AMENDMENT OF SOLICITATION/MODIFICATION OF CONTRACT				1. CONTRACT ID CODE <div style="text-align: center;">J</div>		PAGE OF PAGES <div style="text-align: center;">1   9</div>

2. AMENDMENT/MODIFICATION NO. <div style="text-align: center;">0002</div>		3. EFFECTIVE DATE <div style="text-align: center;">08-Aug-2002</div>		4. REQUISITION/PURCHASE REQ. NO. <div style="text-align: center;">W16ROE-2141-0901</div>		5. PROJECT NO.(If applicable)

**AMENDMENT 0002**

<p align="center"><b>Cost Analysis</b>  <b>Composite Medical</b>  <b>Facility, Thule AB , GL</b>  DACA51-02-R-0016</p>		
<b>Work Breakdown Structure</b>		<b>Amount</b>
Engineering & Design Services to include all fees for Shop Drawing Review, Request For Information, Commissioning of Mechanical Systems, Review Meetings, Start ups, As-Builts, etc.

**Thule Composite Sample  
July 2002**

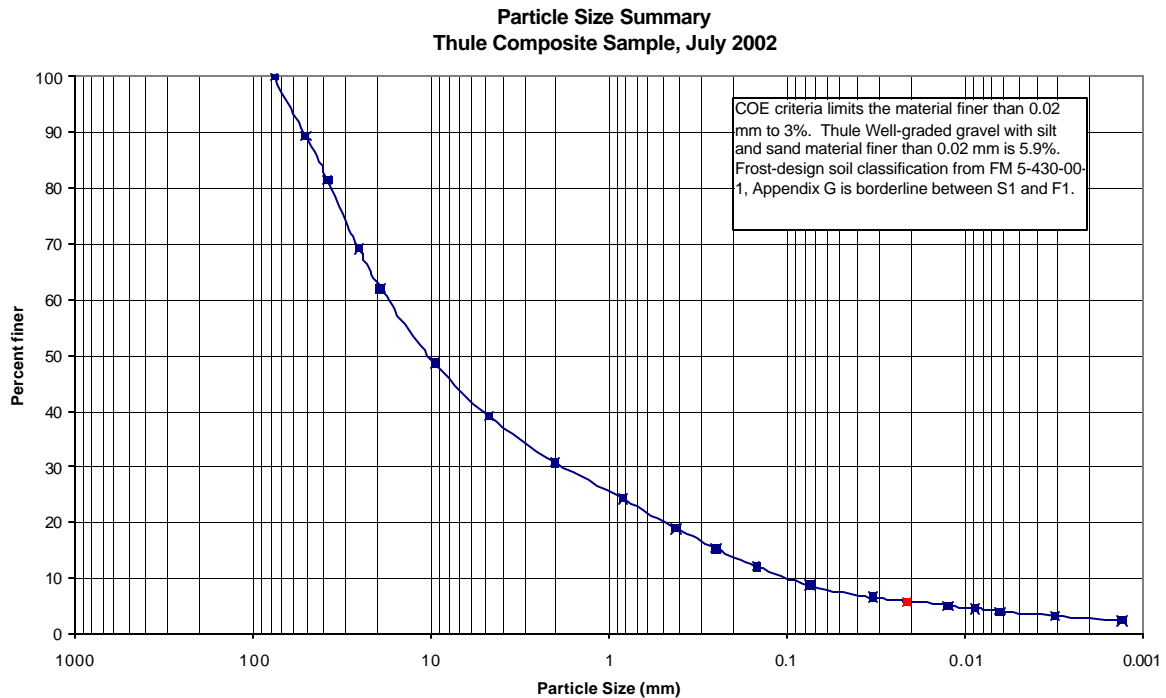
A non-frost susceptible (NFS) gravel source was to be provided from a location at Thule known as the BMEWS site. Cold Regions Research & Engineering Lab was on site recently and brought back gravel samples for testing of the material. These are the results of the grain size analysis of those gravel samples:

Current Corps of Engineers frost-susceptibility criteria limits the amount of material finer than 0.02 mm to 3 percent. Our sample had 5.9% finer than 0.02 mm (see attached results and plot). According to this test, our potential non-frost susceptible (NFS) gravel source may have to be cleaned before it can be used at the project site. Thule dirt tends to cling to everything (even rocks). The sample taken had to be sieved and washed. The NFS on site will have to be cleaned. Most of the dirt can be removed by dropping the gravel off a very high object such as a conveyor belt in a strong wind. To get any additional dirt off, the gravel may have to be washed and sieved to get to the NFS fill.

Current Corps of Engineers frost-susceptibility criteria limits the amount of material finer than 0.02 mm to 3%
